<b>DOCKETED</b>	
<b>Docket Number:</b>	09-AFC-01C
<b>Project Title:</b>	BP Watson - Compliance
<b>TN #:</b>	264549
<b>Document Title:</b>	PETITION TO AMEND - Modification of the CEC Jurisdictional Site Boundaries to Exclude Areas of Previous Construction Activities
<b>Description:</b>	PETITION TO AMEND - Modification of the CEC's Jurisdictional Site Boundaries to Exclude Areas of Previous Construction Work.
<b>Filer:</b>	Anwar Ali
<b>Organization:</b>	California Energy Commission
<b>Submitter Role:</b>	Commission Staff
<b>Submission Date:</b>	7/2/2025 5:11:56 PM
<b>Docketed Date:</b>	7/2/2025

**Subject:      Watson Cogeneration Project (85-AFC-01C): Petition to Amend**

**WATSON COGENERATION PROJECT  
(85-AFC-01C)  
PETITION TO AMEND**

**Figure 1: New Sub 1F 220 kV GIS**

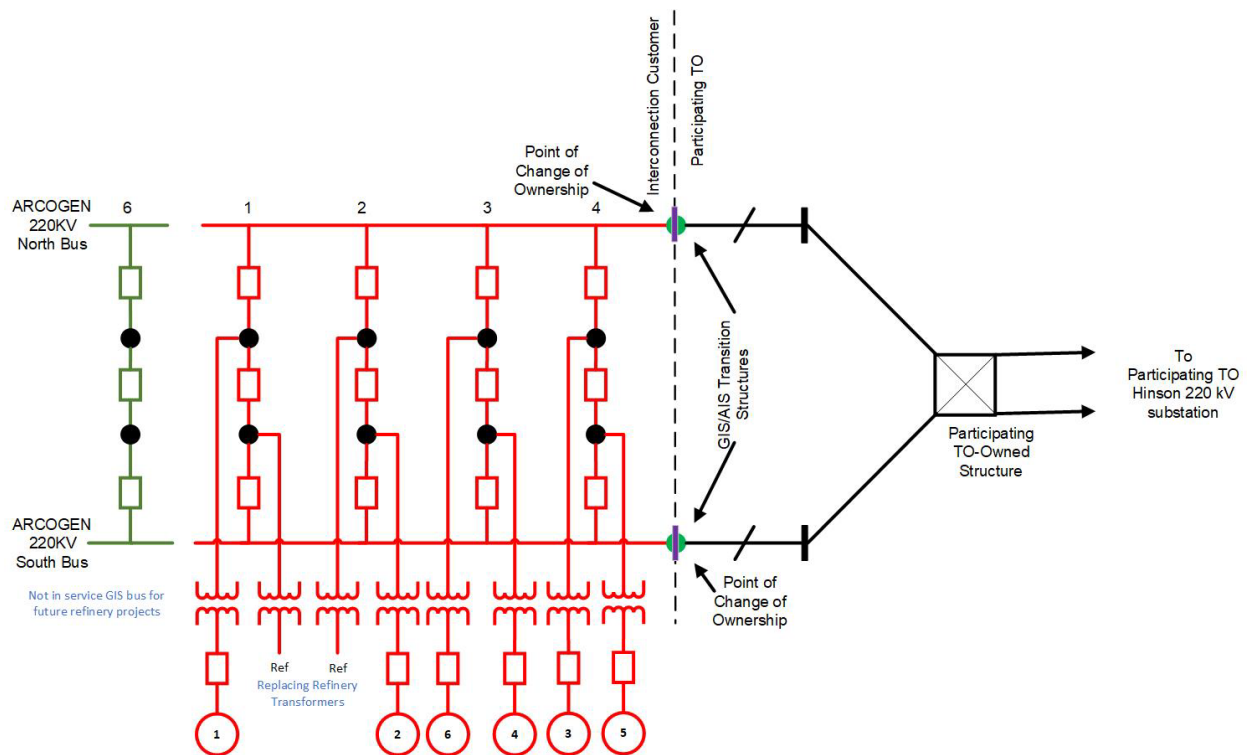
This proposed change does not require any new language for any conditions of certification and does not affect the design or operation of the Watson Cogen. The new Sub 1F 220 kV GIS are depicted in Figure 1 in spot 6, between the ARCOGEN North and South 220kV bus.
